Date: December 27, 2018
To: Garett Stevenson, Planner
From: Brandon Sloan, Manager of Long Range Planning & Policy Planning
Dayna Edwards, Senior Planner (Urban Design)
Subject: Draft Plan of Subdivision 30T-18201
Official Plan Amendment OP 18/005&006/B/GS
Zoning By-law Amendment ZC/006&007/B/GS
Bleams Road and Gehl Place
Kitchener Green Ltd. & 2079546 Ontario Inc.

Date: November 2, 2018
To: Garrett Stevenson, Planner
From: Victoria Grohn, Heritage Planner
cc:
Subject: Draft Plan of Subdivision Application 30T-18202
Official Plan Amendment Application OP18/006/G/GS
Zoning By-law Amendment ZBA18/007/G/GS
161 Gehl Place "Application 2"
Kitchener Green Ltd. & 2079546 Ontario Inc.

Date: November 5, 2018
To: Garrett Stevenson, Planner, Development Services
From: Mark Parris, Landscape Architect, Parks & Cemeteries Division
cc:
Subject: **Operations Review and Comments**
Subdivision: **30T-18201 & 18202**
Stage: **Draft Plan of Subdivision**

**Re: Draft Plan of Subdivision Application 30T-18201
Official Plan Amendment Application OP18/005/B/GS
Zoning By-law Amendment ZBA18/006/B/GS
Bleams Road "Application 1"
CITY OF KITCHENER
&
Draft Plan of Subdivision Application 30T-18202
Official

Rosenberg Secondary Plan
MATTAMY COMMUNITY
SWM FACILITY 1 - PLAN VIEW

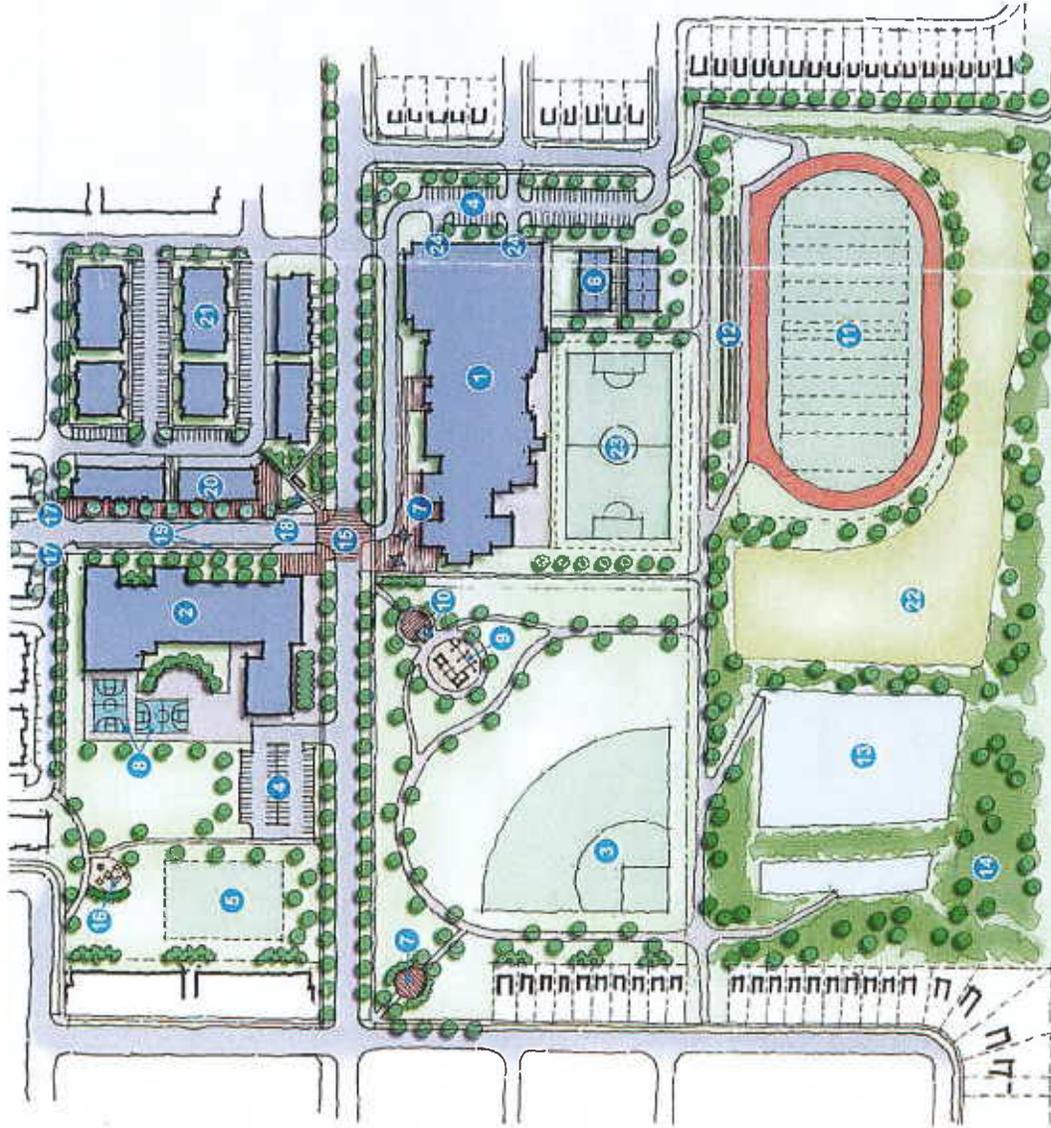
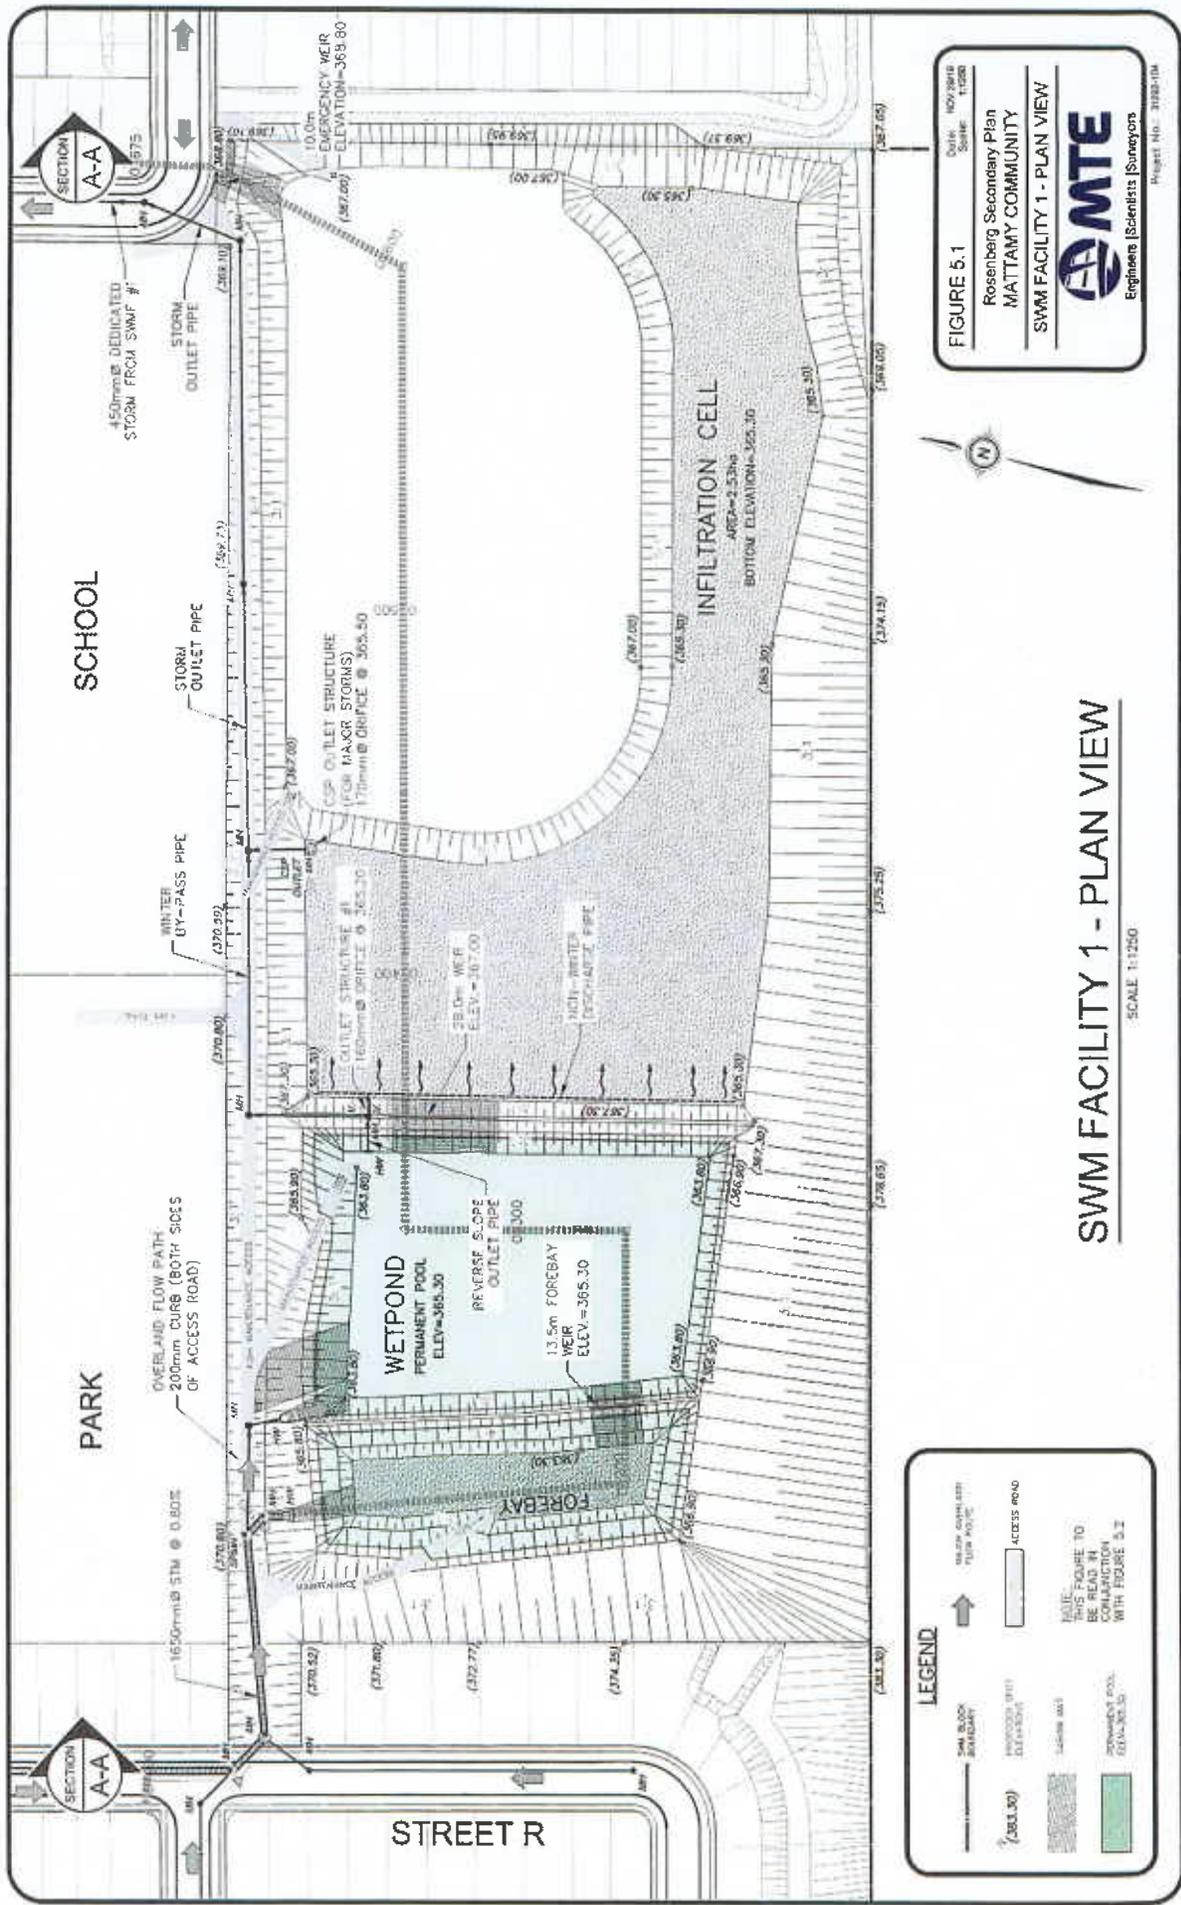
See attached. The track and field area for the school is proposed within the SWM facility, but would only be impacted in the event of a 100 year flood. This would be outside of the infiltration cell.

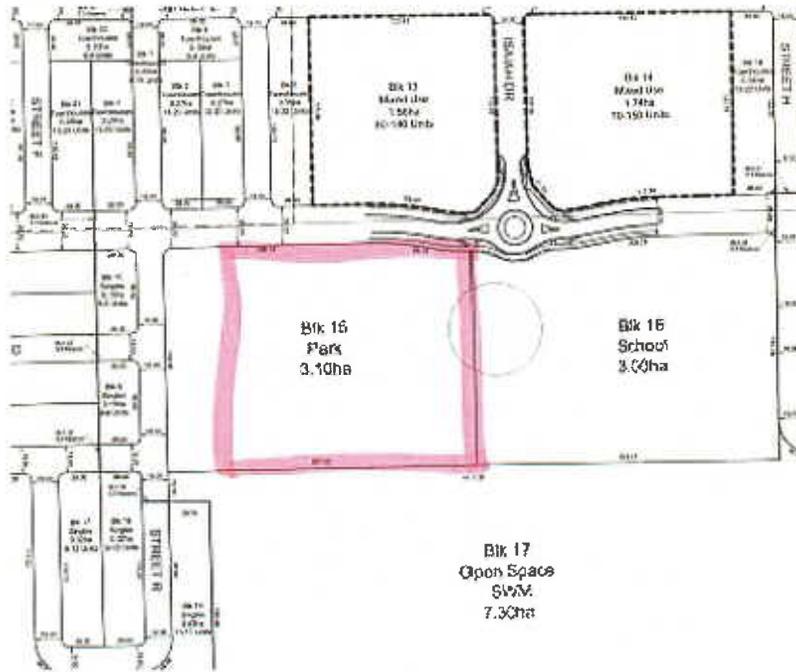
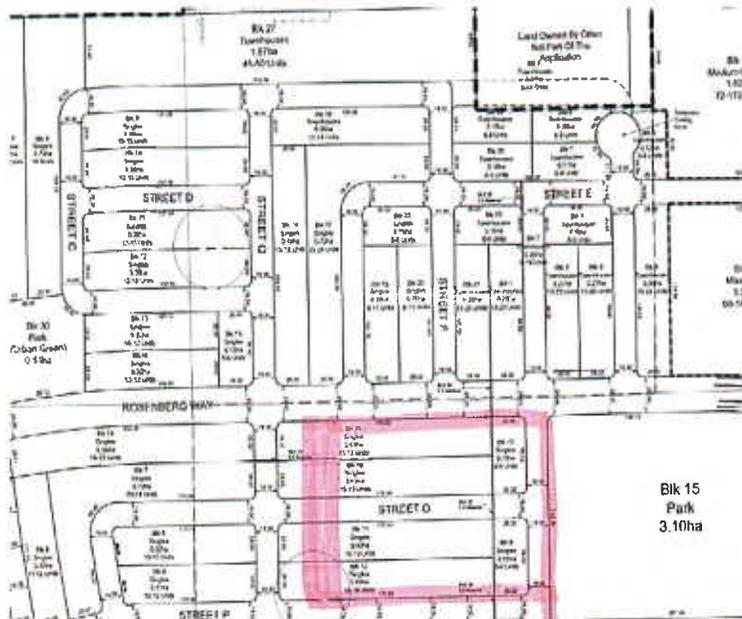
We would appreciate an opportunity to meet with you in person to discuss the location of our school site within this draft plan of subdivision. We feel it would be appropriate to invite the Waterloo Region District School Board to this meeting to discuss how school accommodation will be handled within this area.

Location 1: Stage 3, Block 15 (currently designated as a 3.10ha park)

Location 2: Stage 5, Land west of block 15 (currently designated as Blk 9, Blk 10, Blk 11, Blk12, Blk 25, and a portion of street O).

Location 3: Stage 4, Land at the corner of George Israel Street and Rosenberg Way (currently designated as Blk 30, part of Blk 7,8, 11, 12,13, and 14, and a portion of street C).

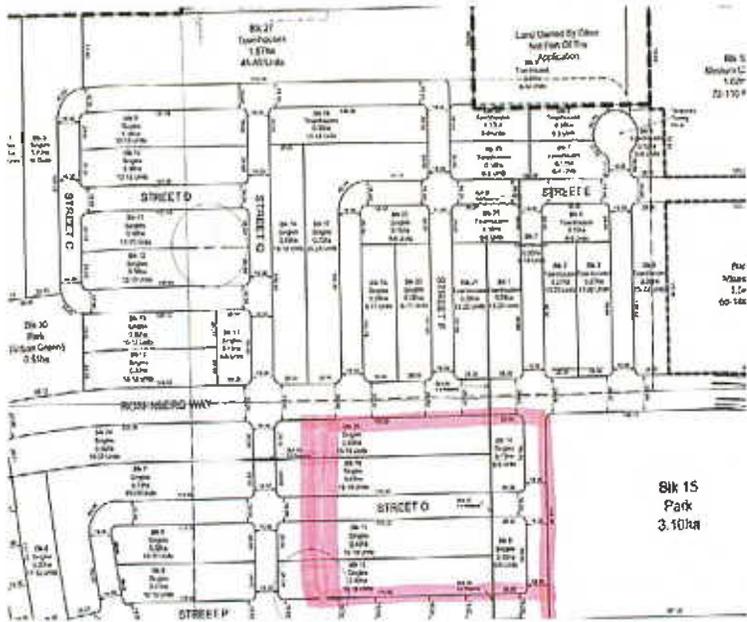
Location 1: Stage 5, Land west of block 15 (currently designated as Blk 9, Blk 10, Blk 11, Blk12, Blk 25, and a portion of street O).

Location 2: Stage 4, Land at the corner of George Israel Street and Rosenberg Way (currently designated as Blk 30, part of Blk 7,8, 11, 12,13, and 14, and a portion of street C).
